**MACEDONIA PLANNING COMMISSION
MEETING AGENDA
JULY 18, 2022**

- 2) Mr. Zickafoose is proposing a pickup window, revised parking and dumpster relocation for Chipotle located at 8195 Golden Link Blvd.

- 3) Mr. Lindsley with Kimley-Horn is proposing the installation of electric charging stations at 8100 Macedonia Commons Blvd.

To: Planning Commission
From: Joe Gigliotti, City Engineer
Date: 07-05-22
Re: Planning Commission Review Comments: Chipotle

ENLARGED SITE PLAN

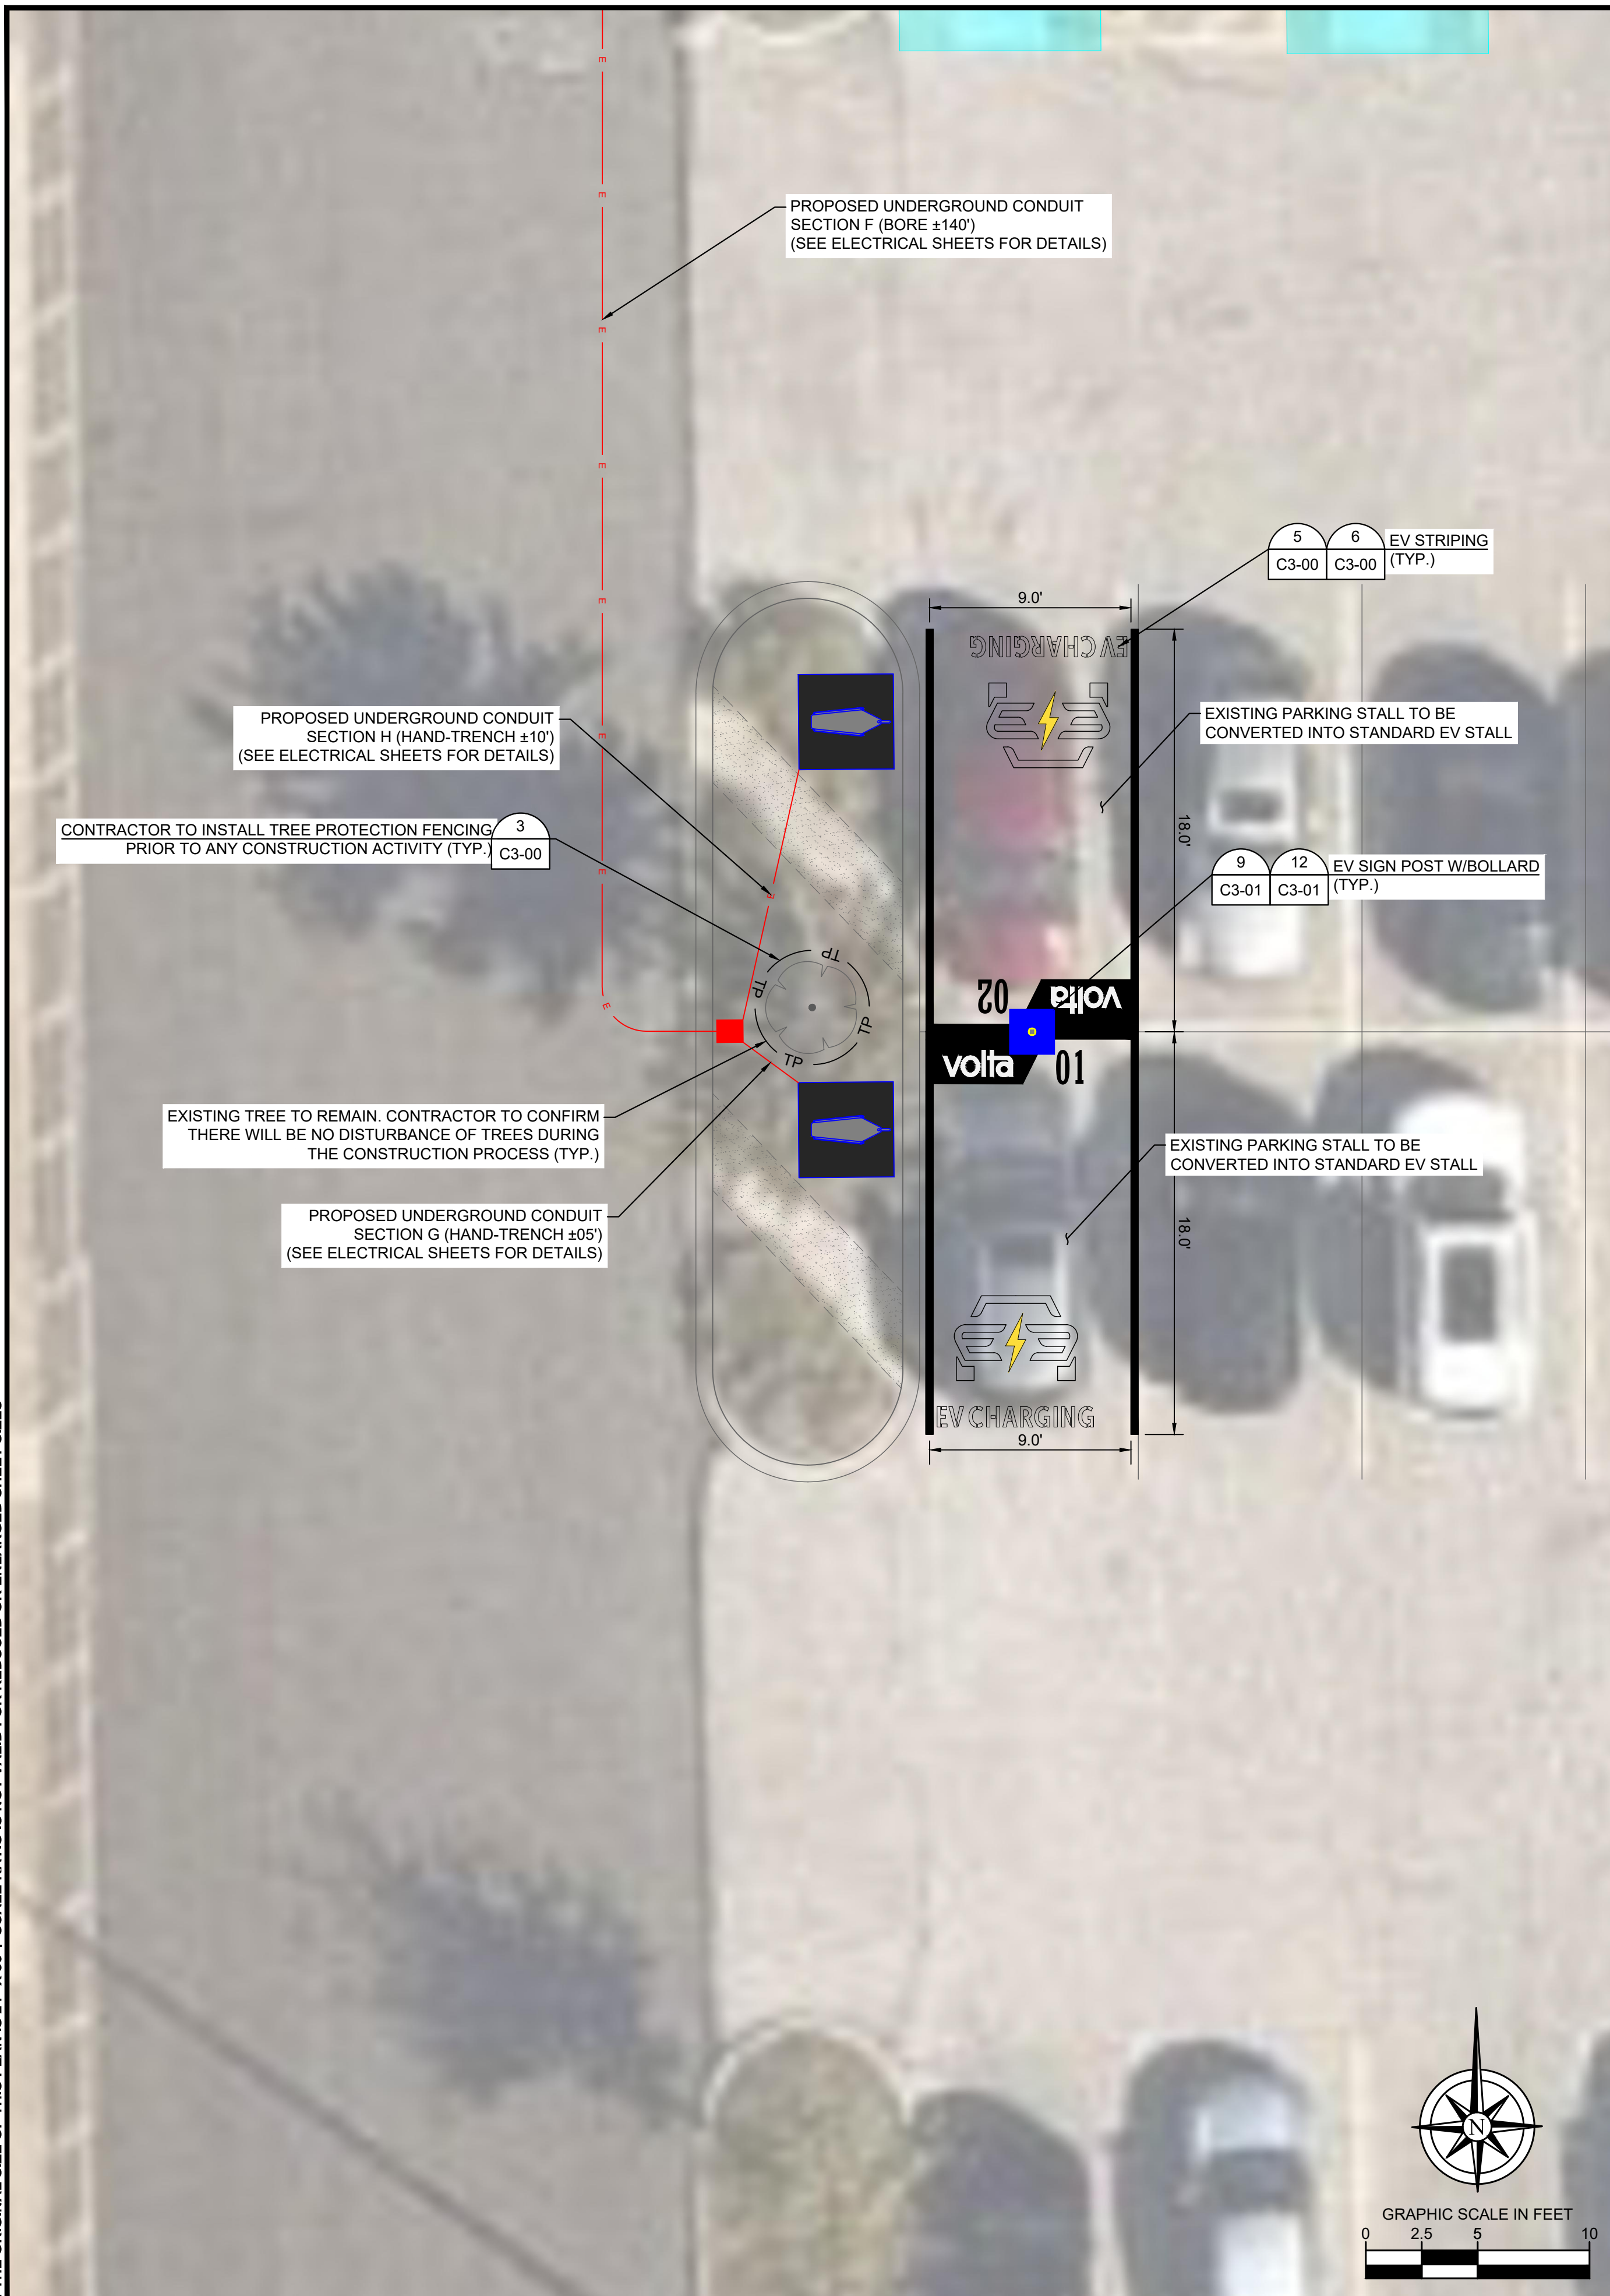
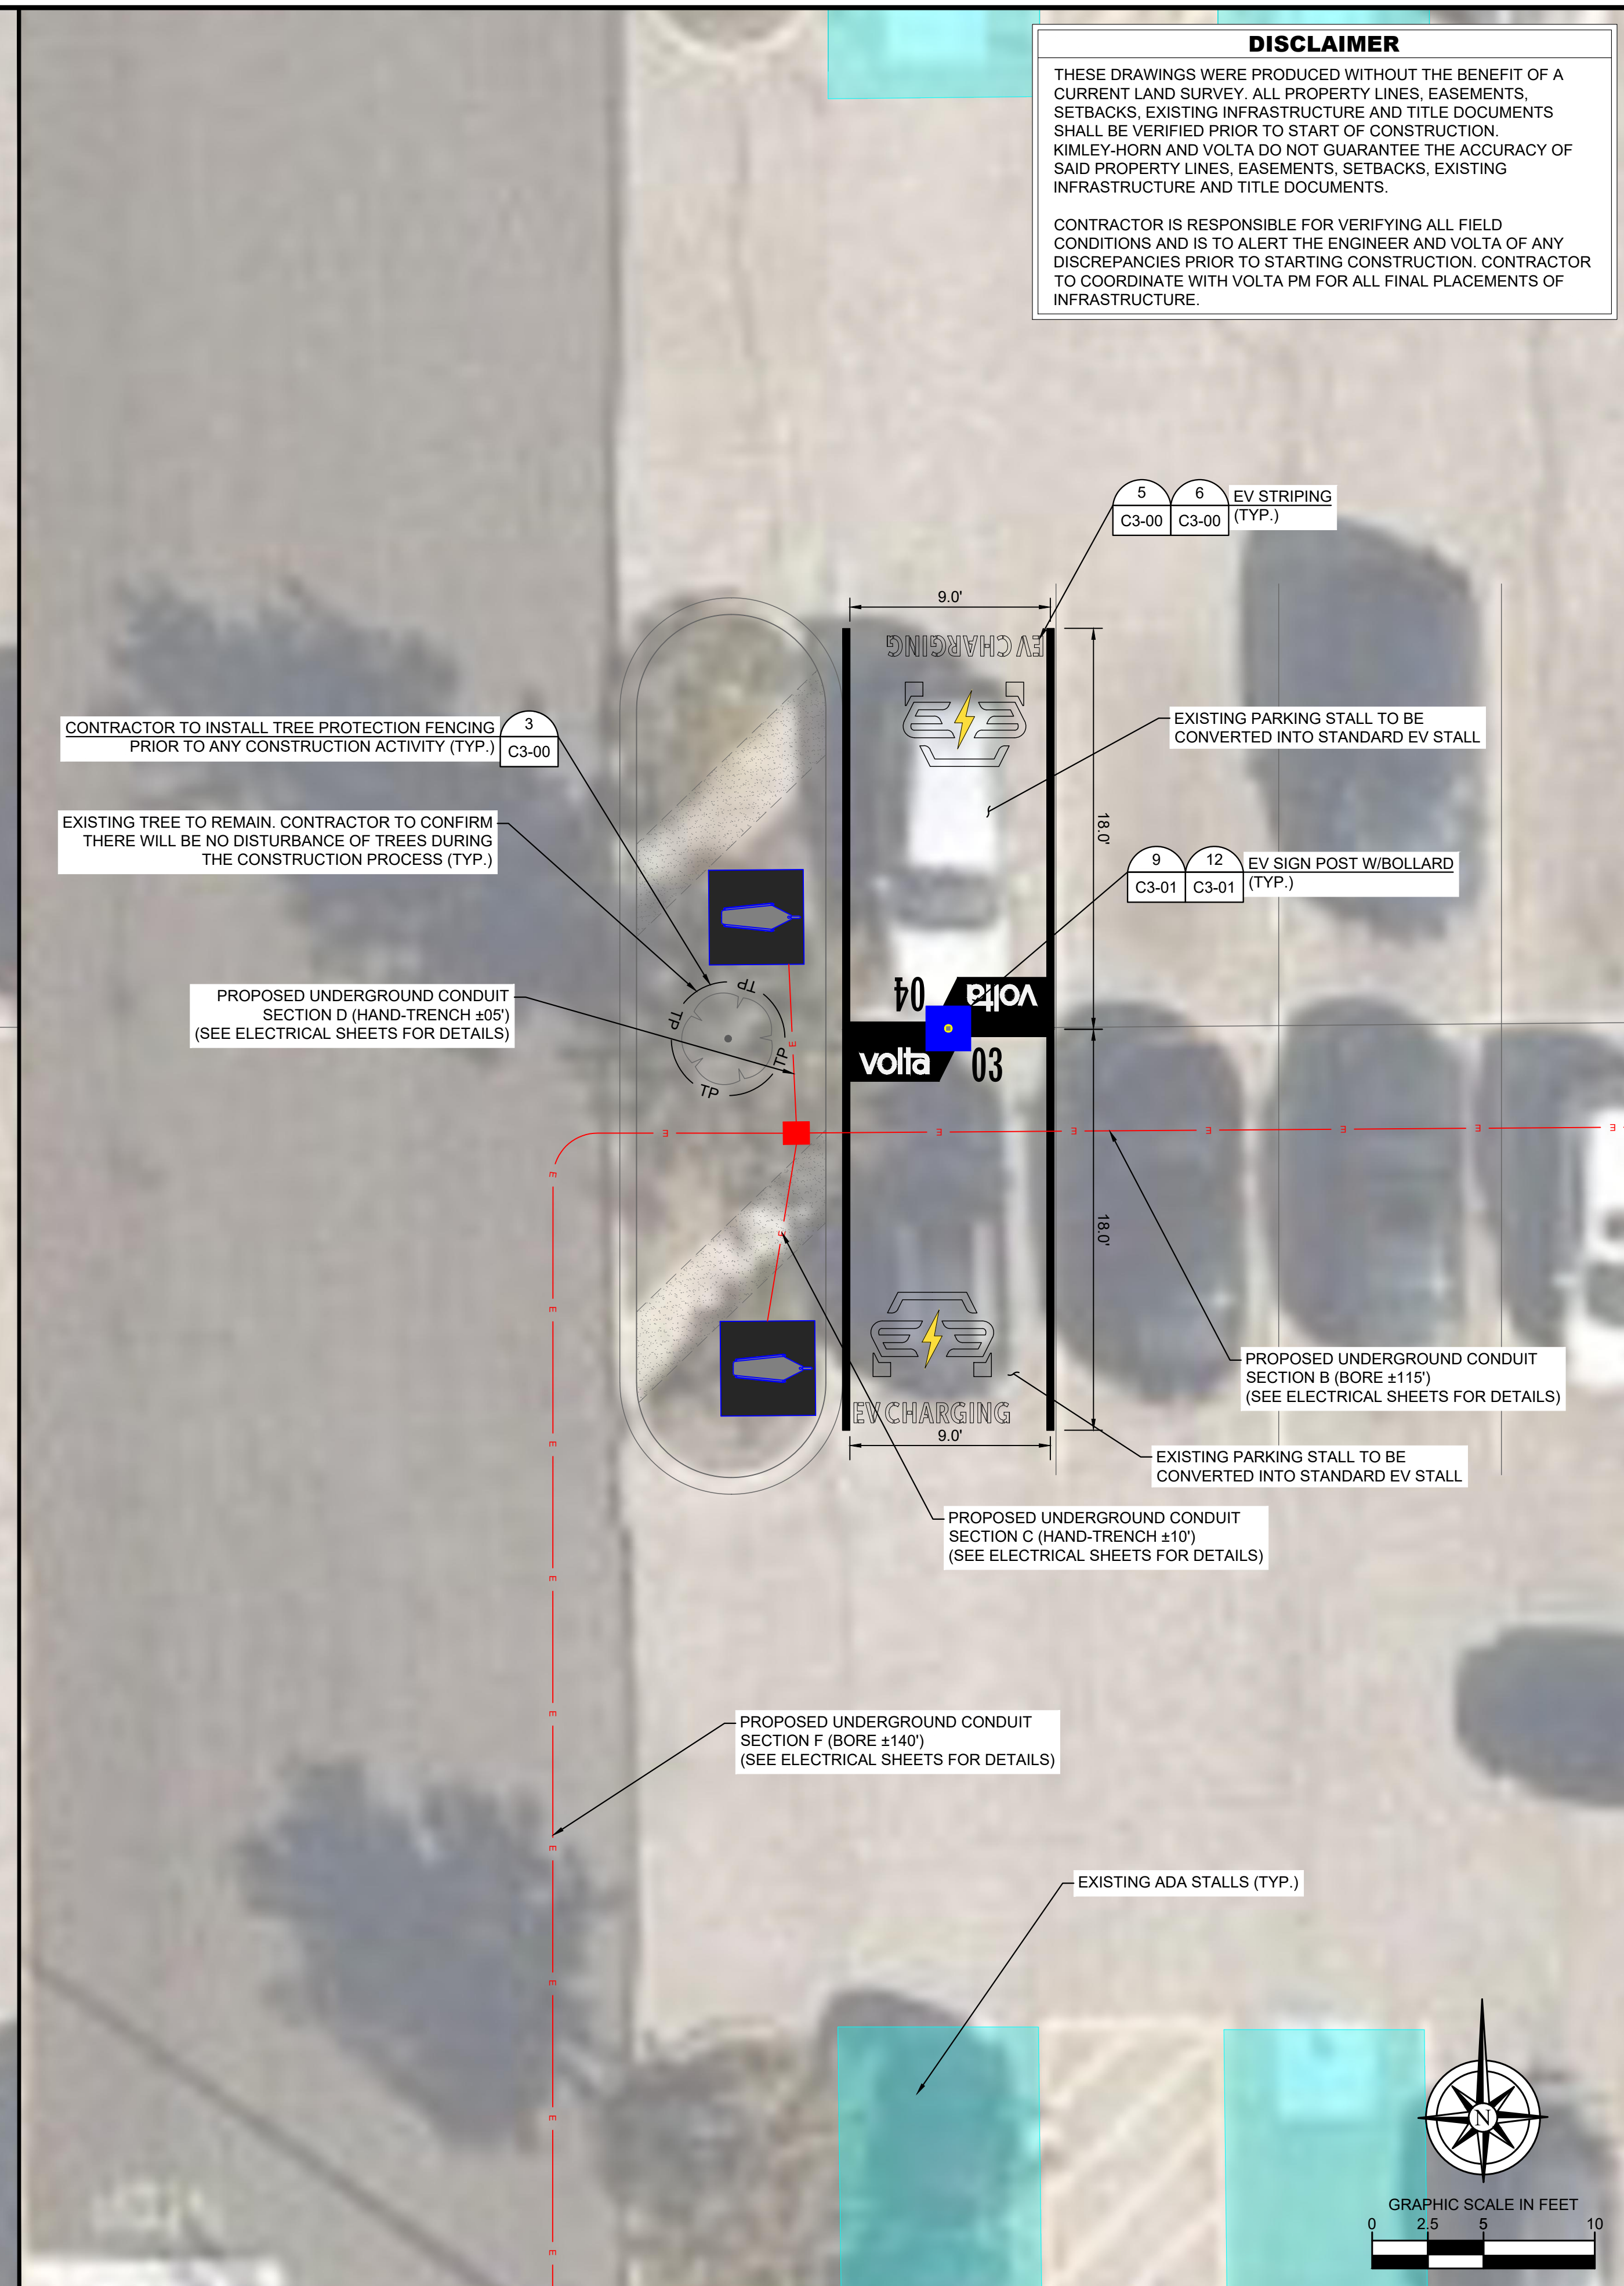
The only minor issue I foresee going forward with this request is the need to properly screen the charging station equipment from Macedonia Commons Boulevard. Moreover, potential impacts to the existing landscaping must be considered. Given this, a landscape plan prepared by a Landscape Architect should be provided for review and approval. If the Commission's agrees, I can review and approve the landscape plan administratively. Otherwise, the plan should come back to the Commission for approval.
